Product Change Notification (PCN)

PCN Number	506376	Date Issued	November 28, 2018
Reason for Change	Change to Product		
Change Type Description	This letter is to inform you that changes are being made to the part(s) identified in this Notice. The change may affect the fit, form, function or appearance of the parts, or it may result in a change to the specification. The pictures below show an example of the possible differences.		
Assessment of Change	Passed FAI		
Internal Molex Qualification Date	November 12, 2018		
Sample Availability Date (Changed Part)	November 12, 2018		
Planned Implementation Date	June 03, 2019		
Method of Identifying Change	Product made after planned implementation date can contain the change

- PCN#506376 - 16B HC top entry & side entry Hoods round shaped

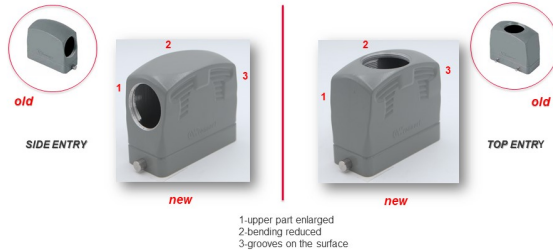
- As part of our continuous improvement process, we/Molex HDC have upgraded our 16B High Construction hoods, Top & Side entry.
- The upper part of the hood has been enlarged (see picture point 1), the bending at the top has been slightly reduced (see picture point 2).
- This change will ensure a better performance even when connected to cable glands of bigger sizes, such as PG29 and M40.
- Even the aesthetic of the surface has been renewed with a new design for the grooves (see picture point 3).
- This change involves both the form and the function of the products.
- See the attached part numbers list. (16B HC Hoods TE & SE).
- Qualification Reports and samples available upon request after the date shown above.
